Exhibit E-4

Confirmed Track Separation Distances Less Than 15 Feet (Phases 1 and 2)

Conditions to Approval Of Deviations Required By The Proposed Long Bridge and L’Enfant 4th Track Project

Between CFP - 111.2 and CFP - 112.35 (the “Exhibit E-4 Locations”)

ENHANCED VAL MAPS - DESIGN
 R1A - L'ENFANT FOURTH TRACK AND STATION IMPROVEMENTS

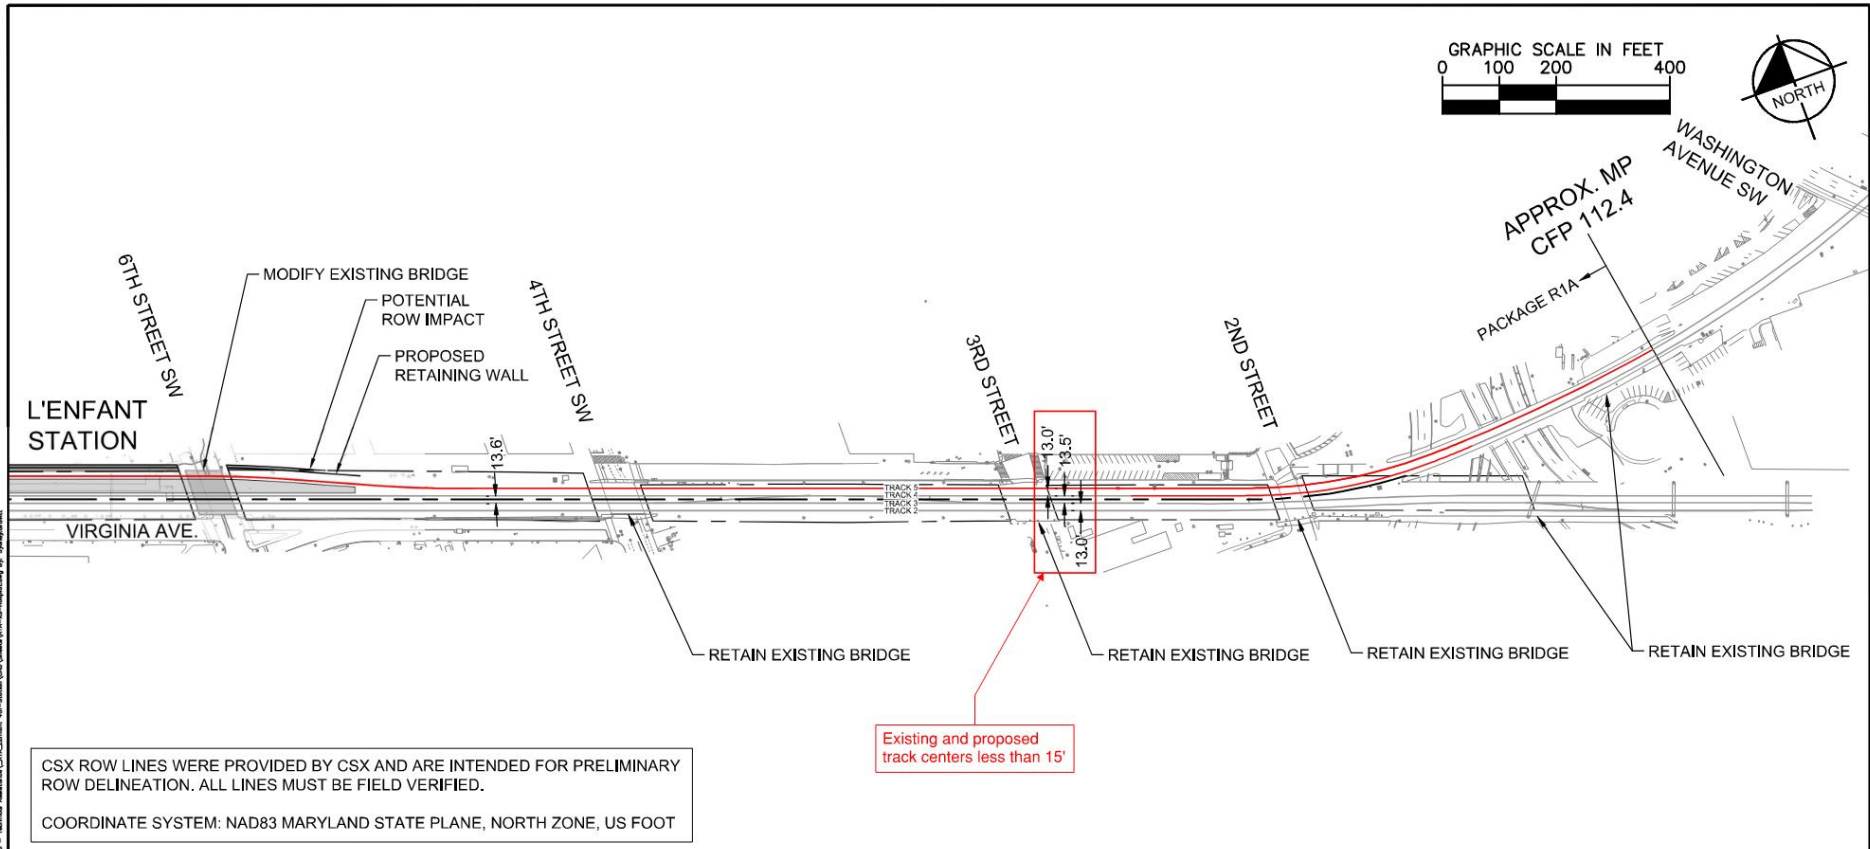
The existing three track corridor, between CSXT Mileposts CFP 111.7 – CFP 112.35, includes mainline track centers spaced approximately 13 feet measured from centerline of track to centerline of track and the existing bridges associated with this project are four-track bridges located above 2nd Street, 3rd Street, 4th Street, and 6th Street. The existing raised structures are designed to accommodate a four-track corridor at substandard (13’-0”) track center spacing. The existing track infrastructure including the siding track currently being used for VRE midday train storage is being conveyed from CSXT to DRPT as-is and the construction of the fourth track is proposed to tie into the existing siding track spaced approximately 13 feet from the centerline of the nearest mainline track. As a result of the existing infrastructure constraints, the proposed track centers do not meet the CSX Standard of 15 feet measured from centerline of track to centerline of track.

1. The three tracks in the east bay of the tunnel underlying Maryland Avenue SW must be constructed with a minimum 14-foot track centers and 7.5-foot lateral clearance.
2. DRPT will design and construct crash walls as required by the Applicable Project Standards (as defined in the Master Engineering Agreements).

3. If required by the Applicable Project Standards, DRPT will construct a crash wall to protect the Mandarin Hotel and any other occupied or bridge structure along the entire area in which a railroad track will be operated within 25-feet.

4. DRPT will install automatic railroad clearance detectors based on the updated horizontal clearances identified in the PE design phase. Further, existing CSXT automatic railroad clearance detector locations will be identified and assessed to determine their feasibility and suitability for continued use.

13. Agreement by DRPT that during final design of the Long Bridge Project, best efforts will be made to maximize the lateral clearance in this area to the extent possible without compromising track centers. In other words, increasing lateral clearance to greater than 7.5-feet would be prioritized, but only to the extent that the 14-foot track centers would not be reduced in any area.

14. Due to the significant existing constraints between CFP 111.3 and CFP 112.35, CSXT will approve a reduction in the track centers of newly constructed track so long as the final design will seek to maximize the track centers through this area, but in no case may the 4th Track be

constructed with track centers less than current track centers between the current Track 3 and VRE Siding. DRPT shall not reduce any existing track centers as a result of this new track.

"RO" TO "L'ENFANT"
TRACK ALIGNMENT (6 OF 7)

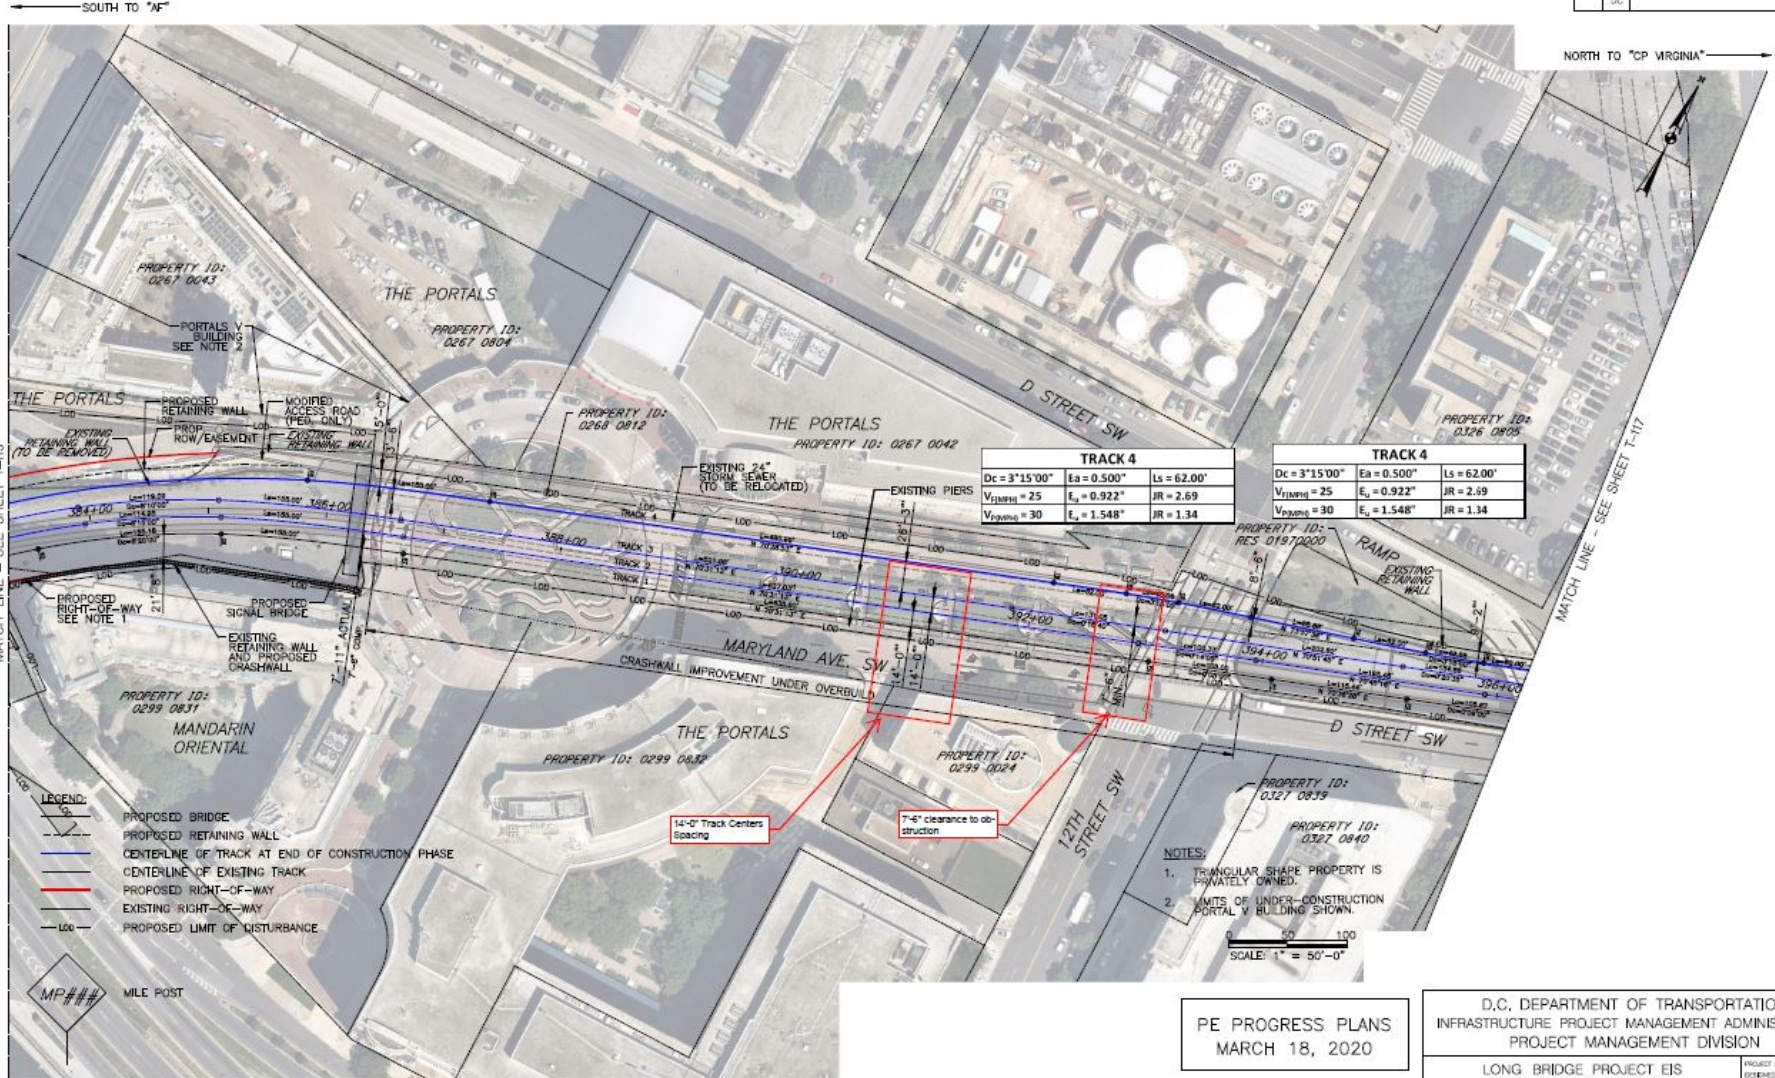
The existing corridor under the Maryland Avenue Overbuild, between CSXT Mileposts 111.2 – CFP 111.7, consists of two (2) CSXT mainline tracks spaced approximately 13 feet measured from centerline of track to centerline of track in one portal under the Maryland Avenue overbuild, and one stub track in a parallel portal north of the CSXT mainline portal, which is separated by a series of structural columns. Adding the proposed third track in the existing mainline portal requires shifting the two existing tracks. The proposed fourth track will tie into the existing stub track in the northern portal which is not wide enough to accommodate more than one track. As a result of the existing infrastructure constraints, the proposed track centers do not meet the CSX Standard of 15 feet measured from centerline of track to centerline of track and the horizontal clearances do not meet the CSX Standard of 9 feet from the centerline of track to an obstruction. The Long Bridge Project proposes to increase the existing spacing of tracks to approximately 14 feet between track centers while maintaining a minimum clearance of 7.5 feet from the existing horizontal obstruction.

12. Agreement by DRPT that at such time in the future when the existing Maryland Avenue SW overhead bridge structures are proposed to be reconstructed, that it will support, or cause DDOT to support, CSXT’s efforts to ensure a minimum 15-foot track centers and 9-foot lateral clearances for the tracks underlying the newly-reconstructed structures.
